URBAN DESIGN CONSULTATION RESPONSE

Design Officer	Azhar Kapadi
Date	14.04.25
Application Reference	24/00993/FUL
Address	Land Opposite To 1-35 Bentley Street, , Rochdale , OL12 6EU,
Proposal	Erection of two apartment blocks comprising 23 apartments (13no 2 bed and 10no 1 bed apartments), together with associated parking and landscaping.

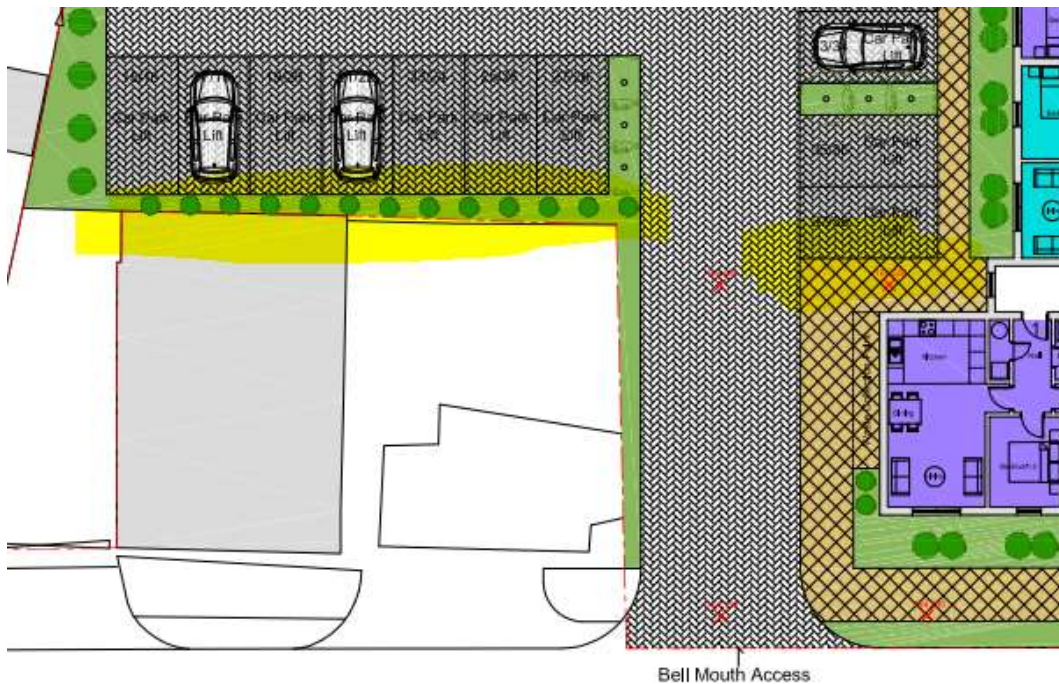
Comments in this consultation are limited regarding site layout and apartment configurations as there have been previous discussions with the planning officer and agent.

In the scheme presented (PREAPP/00047/23), the planning officer was generally satisfied the form and character of the apartment blocks would be acceptable within the existing character of the area, whilst achieving a higher density. There were concerns the building risked looking overly monolithic and concerns regarding the visual dominance of the car park were expressed.

The overall site plan since the pre-application has not changed much so problems such as the parking layout persevere.

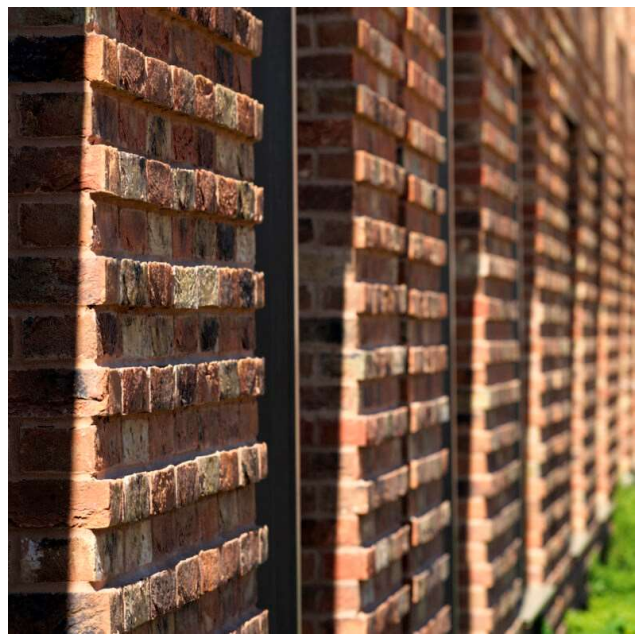
The proposed elevations appear rather blank and lack sufficient visual interest. This issue is compounded by the quality of the submitted drawings, which do not effectively convey the depth, articulation, or setbacks of the various building elements. Incorporating shadows and more accurately representing materials rather than relying on simplistic CAD fills would significantly improve the clarity and effectiveness of the drawings.

Larger windows and better brick articulation would help alleviate this. Brick elevations can be enriched through the use of recesses and projections which the architect has attempted in parts. Structural depth can be created by employing deep window reveals and varying the depth of facing materials. Where the sub division of a façade is less apparent, it is sometimes necessary to employ vertical shadow lines/niches to break it up. Examples below show where this has been done well and where it has been less successful.
